Yorkshire Green Energy Enablement (GREEN) Project

**Document 8.25.1 Applicant's Response to Examining Authority's
Second Written Questions (ExQ2)**

**Final Issue A
July 2023**

Planning Inspectorate Reference: EN020024

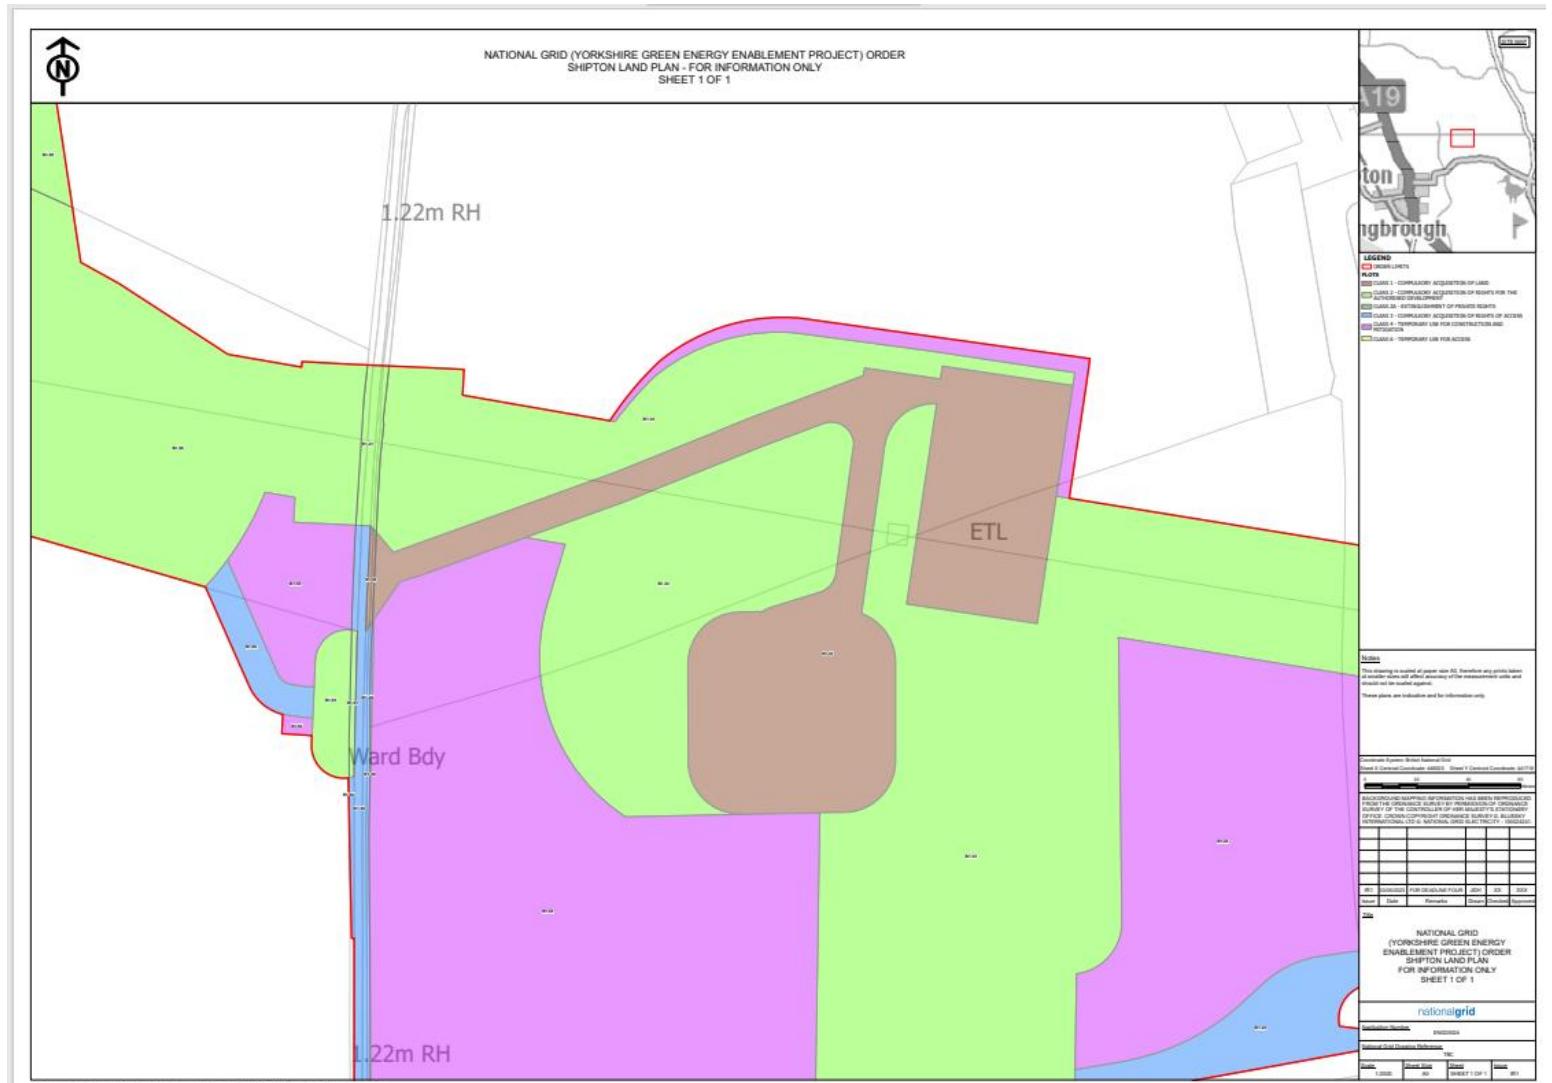
Q4.3.2	The Applicant	<p>Limits of Deviation around Shipton North Cable Sealing End Compound Further to the ExA’s request to consider limiting the Limits of Deviation (LoD) to the north of Shipton North CSEC and your response [REP4-027], action 3:</p> <ol style="list-style-type: none"> a) Provide a plan/ sketch which illustrates limiting the LoD; and b) If possible, in the time, discuss such limits to the LoD with Mr Stephenson/ the Rab family to establish their views and report back in response to this question. <p>Applicant’s Response:</p>

a) The plan shown below illustrates the reduced LoD and was presented to the Landowner, occupier and their agent on 19th June 2023.

<p>b) The plan shown above was presented formally to the Landowner, occupier and their agent as an attachment to a letter dated 19th June 2023 (sent by post and a copy via email to the agent) having been previously discussed with them during a site meeting on 16th June 2023. It was also discussed, and no issues were raised, during a further site meeting with the Rab family and agent on 23rd June 2023. This is the subject of the change request notification issued to the Examining Authority (Change 1) and the change application submitted at Deadline 5.</p>
--	--	---
